November 30, 2022

Re: Parker County Brewing Preliminary Plat (Permit #22-000231) Review #1 – Response to Comments
Site Location: Aling I-20 Service Road, Just Northwest of Kings Gate Road

PRELIMINARY PLAT
LOT 1, BLOCK 1
PARKER COUNTY BREWING COMPANY
AN ADDITION
TO THE CITY OF WILLOW PARK,
PARKER COUNTY, TEXAS

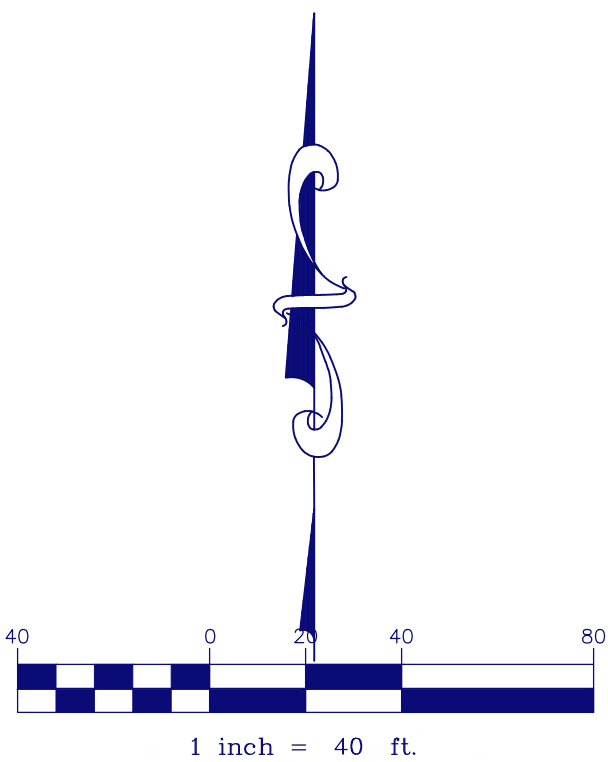
- 1. Owner's Certificate. The word "Parker" is written twice.**
Response: Revised.
- 2. Easements – Show the location and dimension of all easements in accordance with the Subdivision Ordinance. Show and label the offsite sanitary sewer easement.**

Response: Revised.
- 3. Label Curve C2.**
Response: Revised.
- 4. Label the floodway limits on the preliminary plat.**
Response: Revised.
- 5. Floodway easements shall be provided along the natural drainageways. Easements shall be provided in accordance with any and all applicable floodplain management or flood prevention programs, the Federal Emergency Management Agency, the Texas Department of Water Resources and the flood hazard boundary map for the City of Willow Park, Texas.**

Response: Please provide clarification. Is there a specific easement area being requested, in addition to the existing floodway and floodplain limits?
- 6. Label the minimum finish floor elevation.**

Response: Revised and shown 2' above the upstream 100-year flood elevation.

AERIAL EXHIBIT SHOWING OFF-SITE SANITARY SEWER CONNECTION POINT AND EASEMENT.

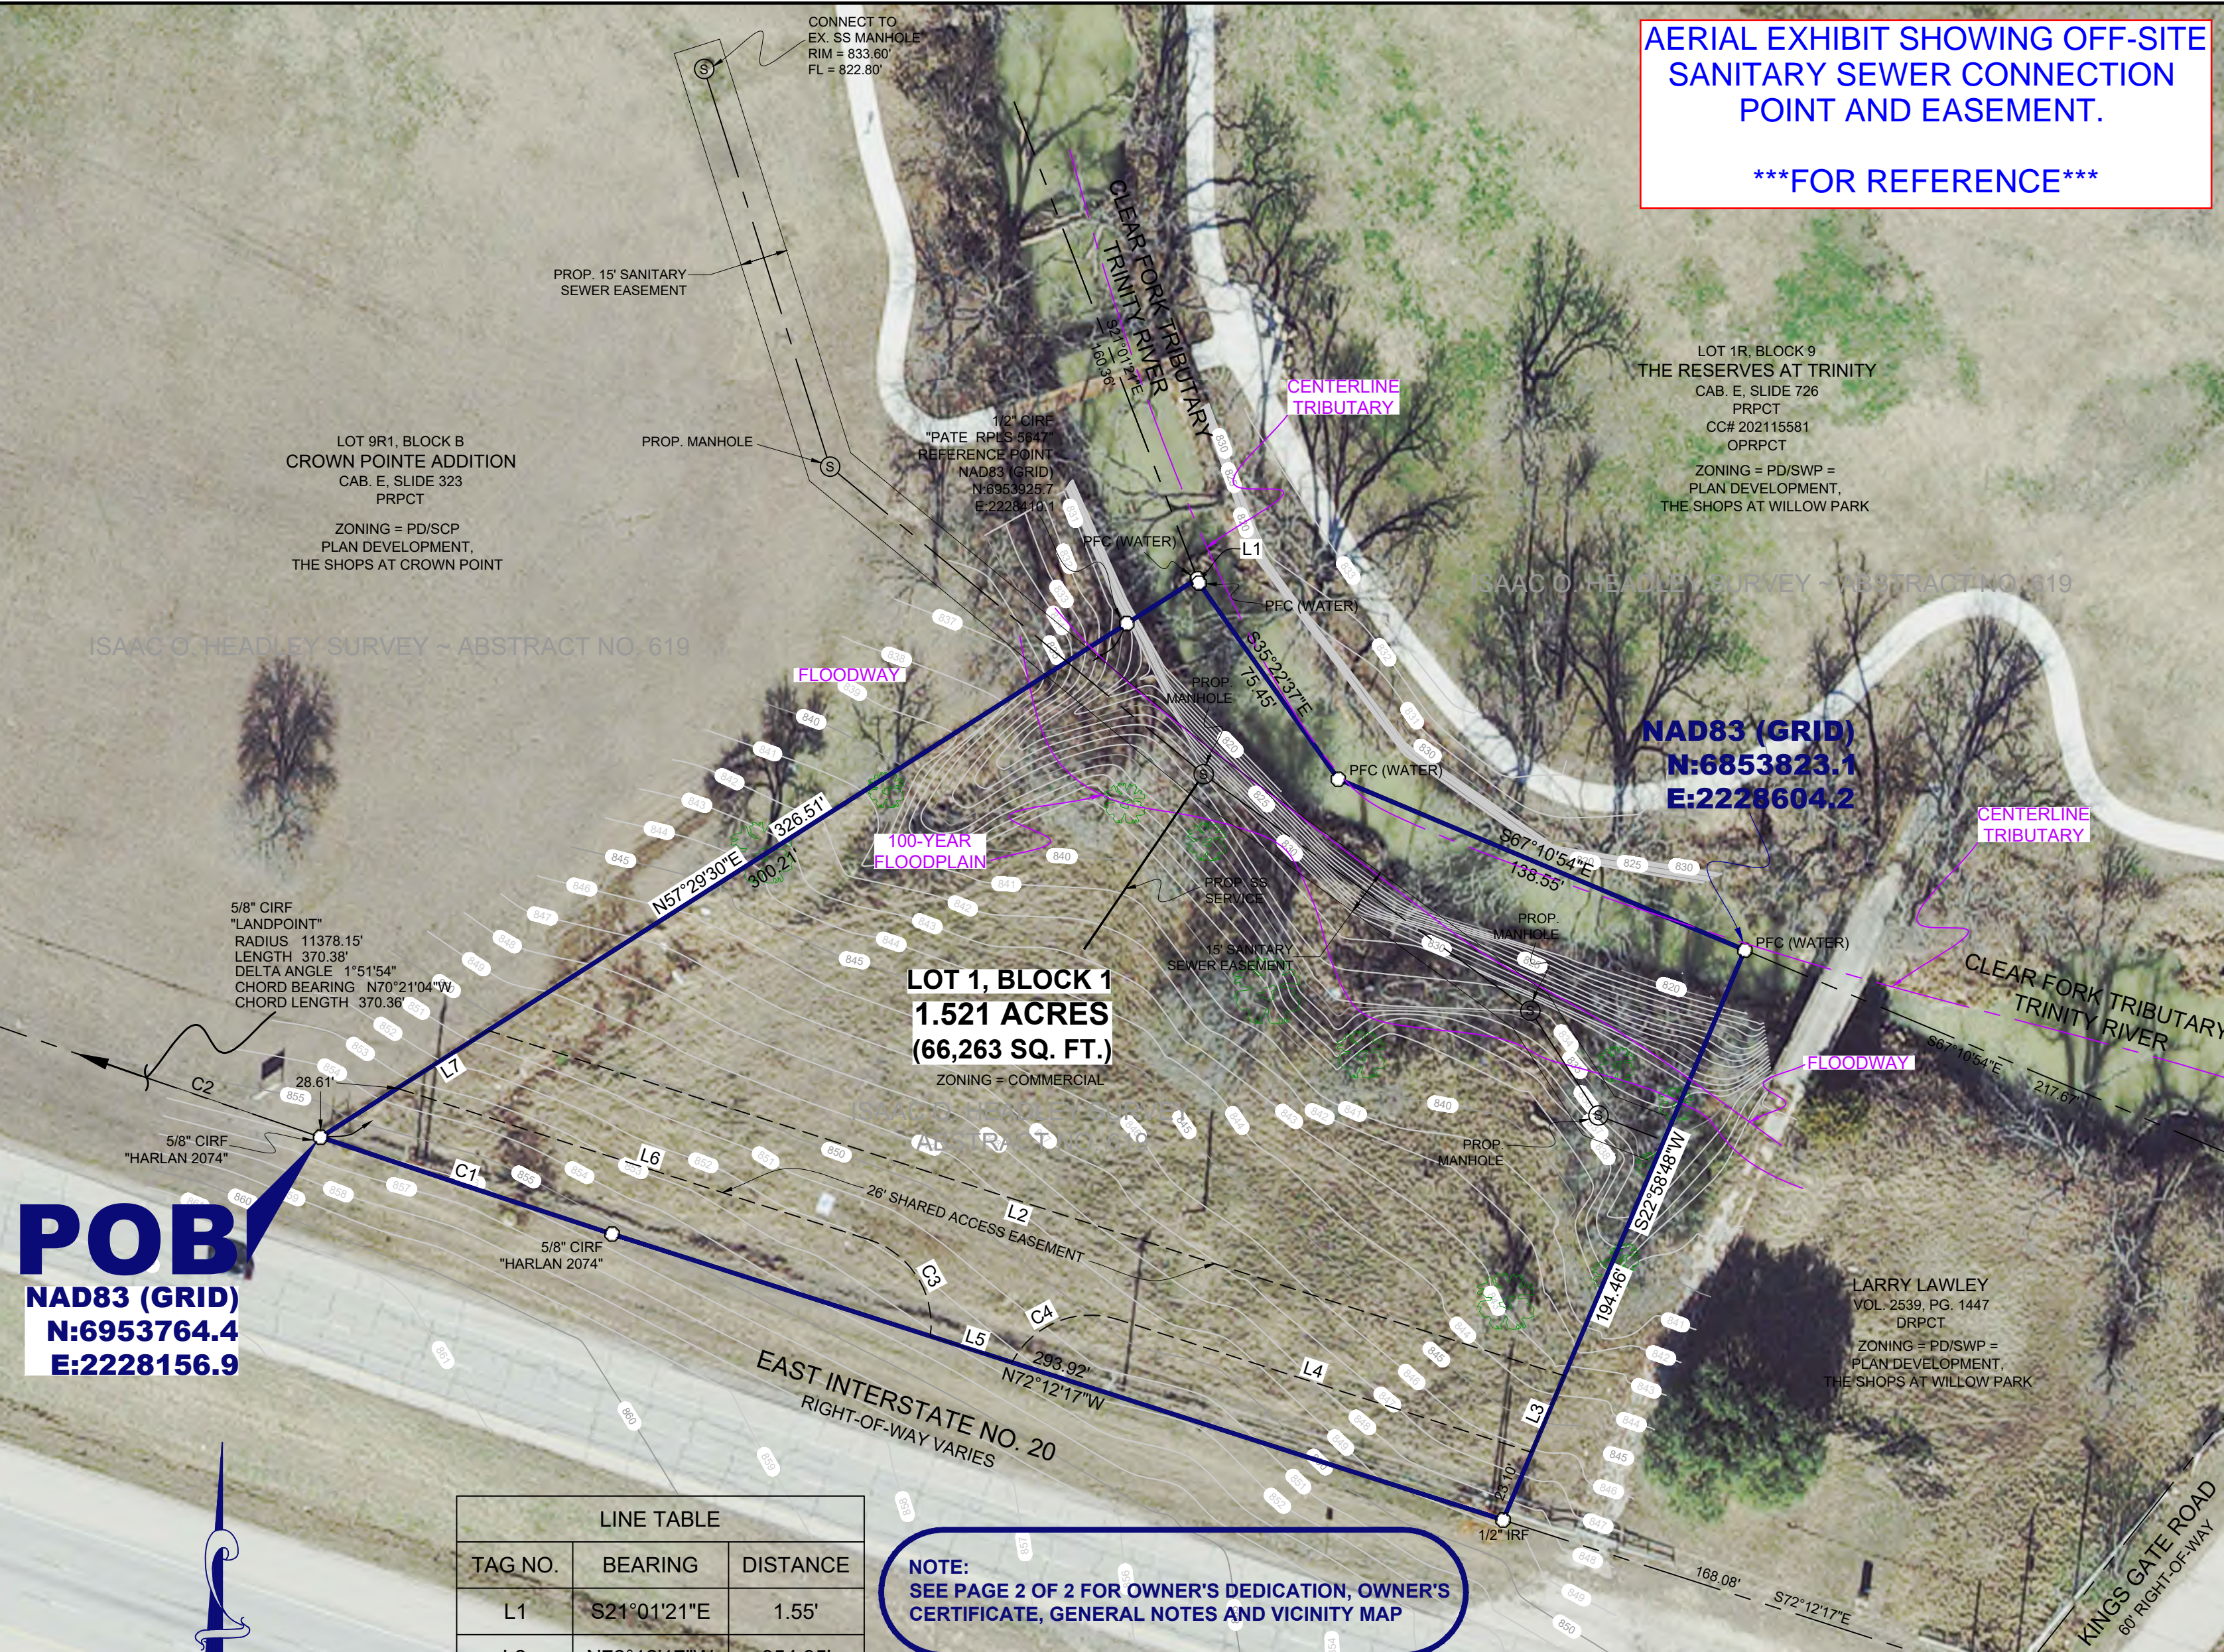
1. **I see no sewer easement. Is the sewer going to be private (owner is responsible for/City has no responsibility) to the manhole located on Wilk’s property.**
Response: Our proposed sanitary sewer easement is now shown on the preliminary plat. The developer will coordinate with the adjacent landowner to ensure a separate instrument easement can be obtained.

- 5. Show the location of the existing sanitary sewer line. An offsite sanitary sewer easement be required.**

Response: Please see the preliminary plat aerial exhibit showing the existing and proposed sanitary sewer lines. Note, we're actively working on an overall utility plan and will provide ASAP for your review.

SITE PLAN	
DESIGNED: ABT	CHECKED: FLS
PROJECT #: 2021-05-10	ISSUE DATE: 11/30/2022
SHEET 1	OF 1

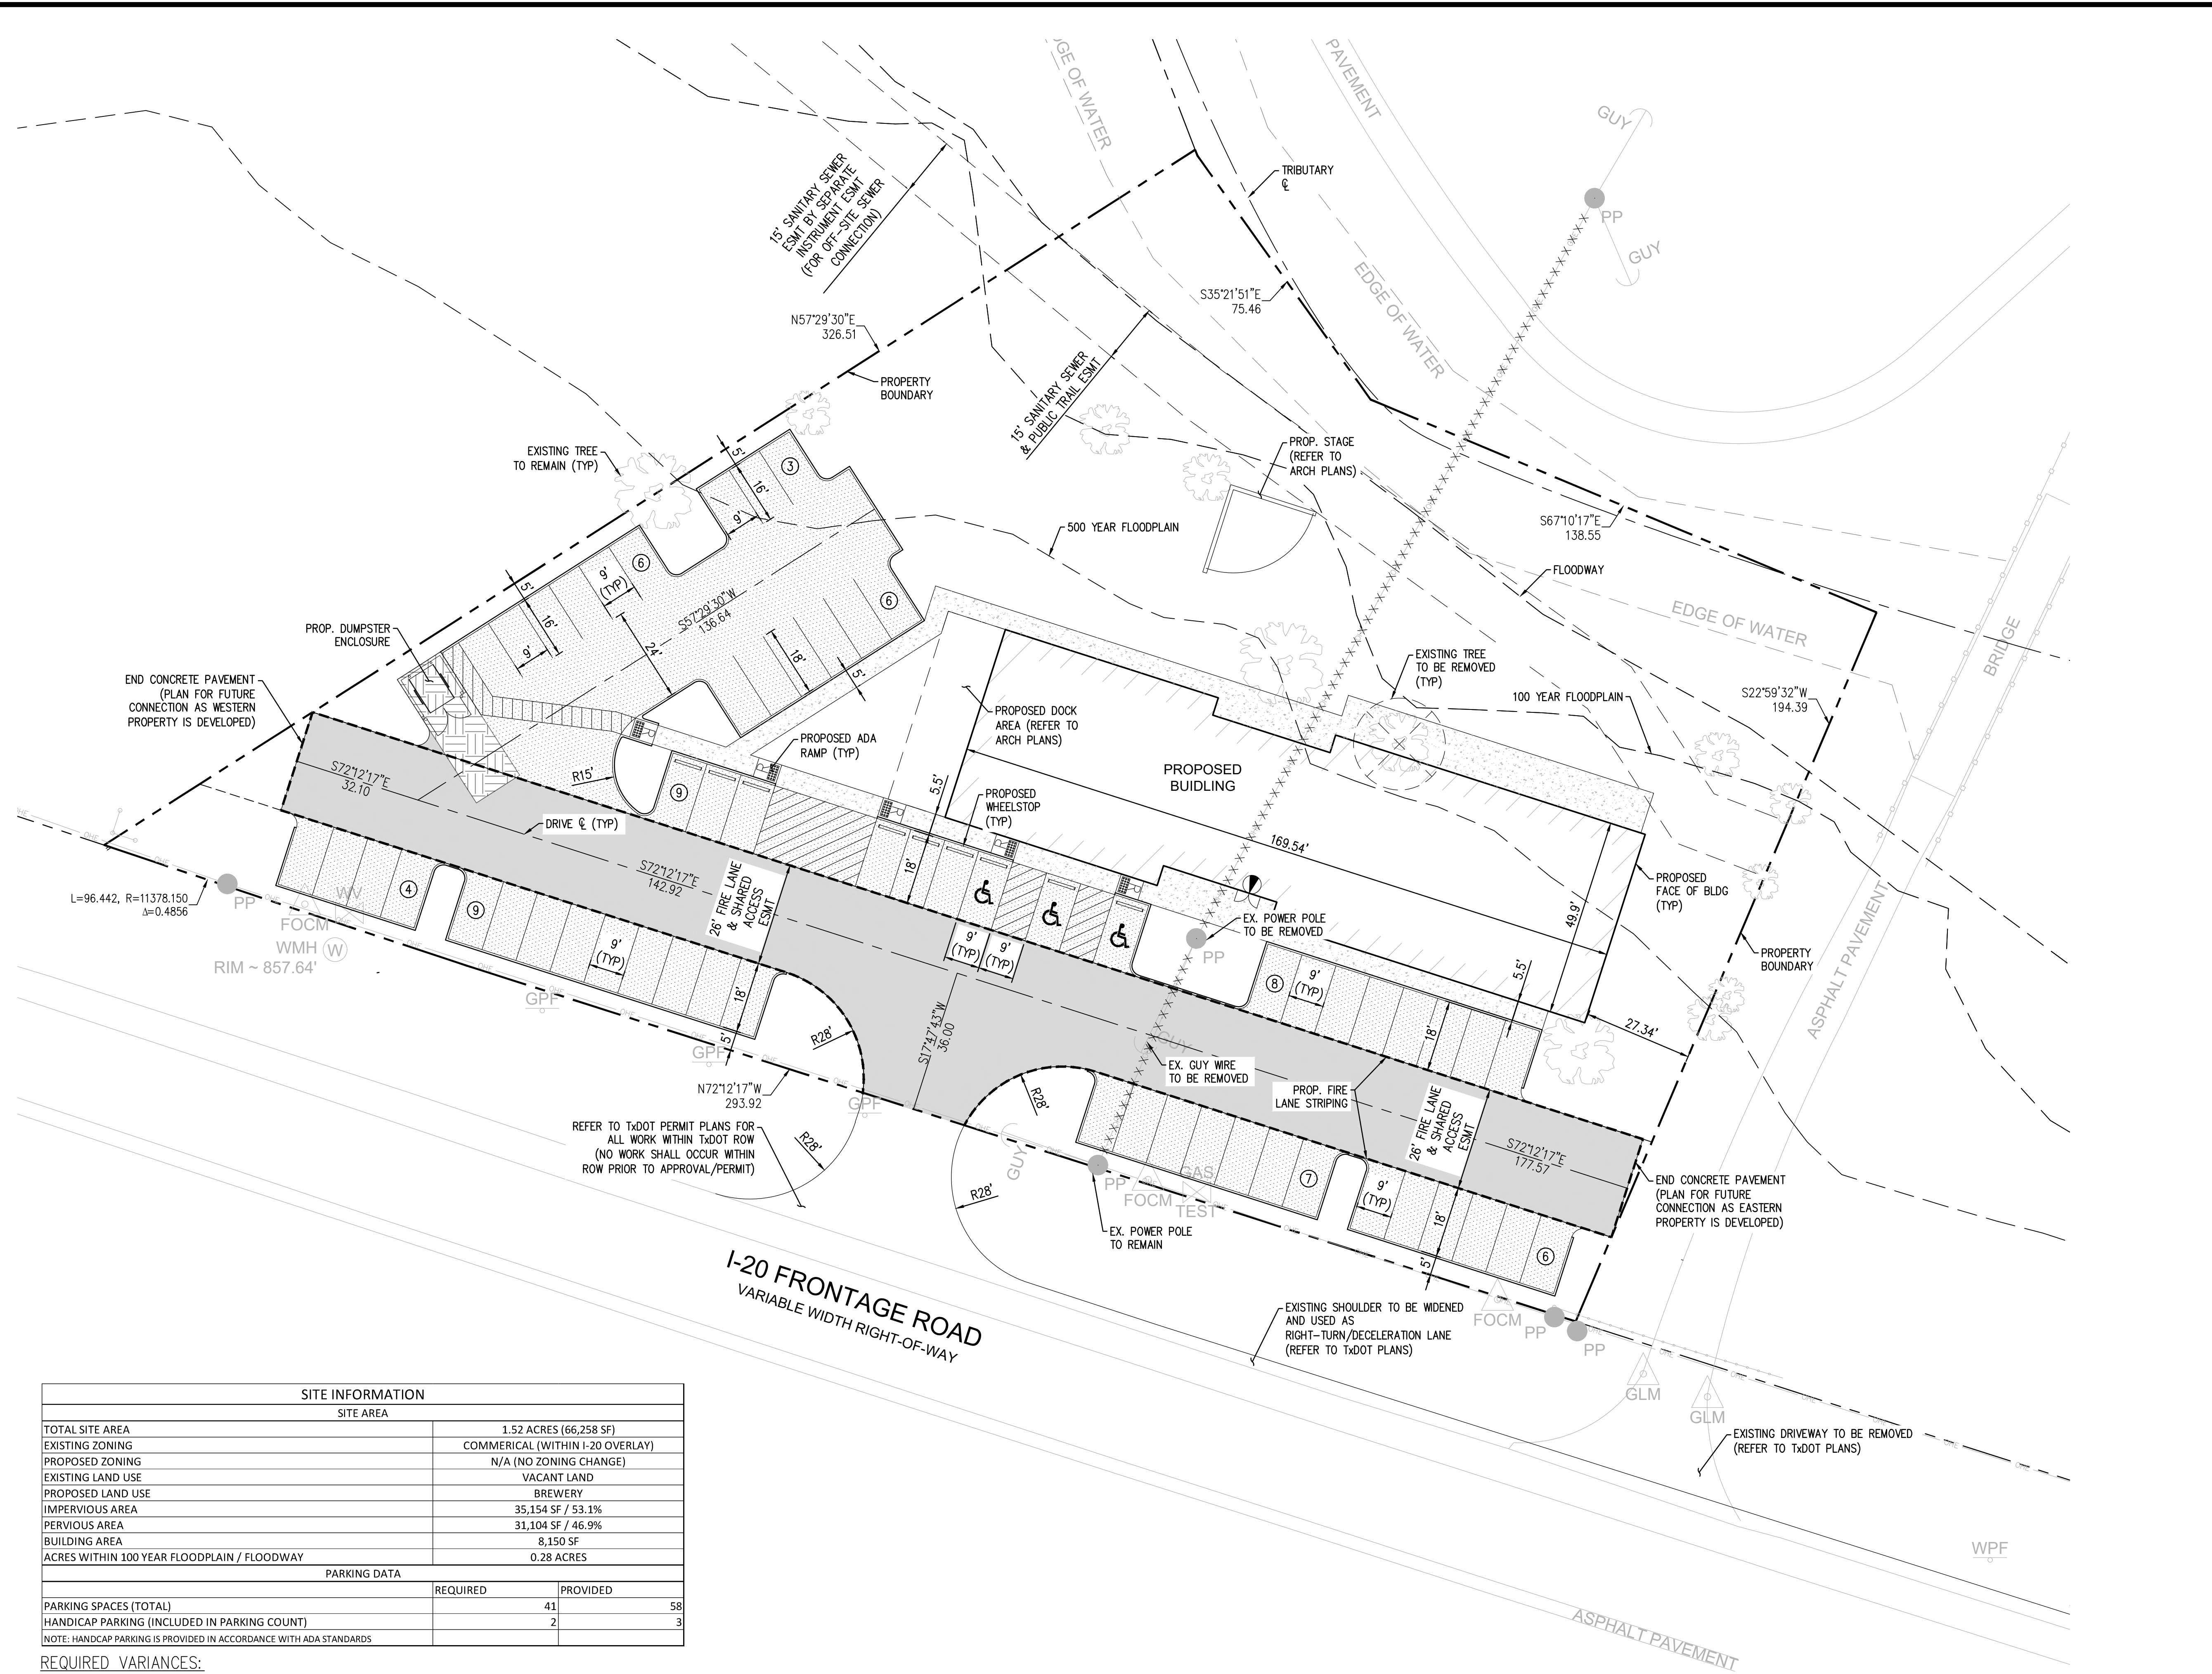
1. **Although the current location of the dumpster is not technically “between” the street and building, you may consider moving it north at the end of the (side) parking lot for aesthetic appearance and also for more ease and access convenience for employees.**

Response: Noted, we’ll coordinate with the design team and potentially relocate as we move forward with the site design.
2. **What is the appearance of the loading area? Is it a platform that trucks pull up to, or will delivery trucks simply pull into the striped area and unload with a hand truck to the building? Design of this area will need to be reviewed further during site plan review.**

1. **Label the centerline of the Clear Fork Tributary of the Trinity River.**
Response: Revised.
2. **Site 23 – TX01183 – Clear Fork Tributary of the Trinity River Watershed Squaw Creek Dam. Shown and label the breach inundation limits on the site plan. A copy of the breach inundation map is available upon request.**
Response: We’re actively coordinating this item with Gretchen. Please let us know if anything is allowed to be constructed within the inundation area.

- 3. It appears that several existing utilities are located along the frontage of the property. A utility easement may be required.**

- 4. Adequate consideration shall be given by the developer to determine how the discharge, leaving the proposed development, will affect downstream property. Clarify how drainage will be handled/conveyed.**

- 6. Consider extending the sanitary sewer line to the east property line for future connection.**

Response: This will not be a traditional loading dock. It is intended as a covered area for receiving deliveries and an overflow outdoor space for large outdoor brewery events. Parker County Brewing Co. will not permanently store materials or park equipment in this area.

Response: There is existing overhead electric and a 12" water line. Please let us know if any easements are required.

Response: Additional information will be provided during the construction plan phase and engineering review. Note, this was briefly discussed with Jacob Martin during the pre-development meeting. It was mentioned that the primary concern is erosion since we're immediately adjacent to the floodplain.

Response: Please let us know if this is required. Our development only needs a service line to the northwest corner of the building.
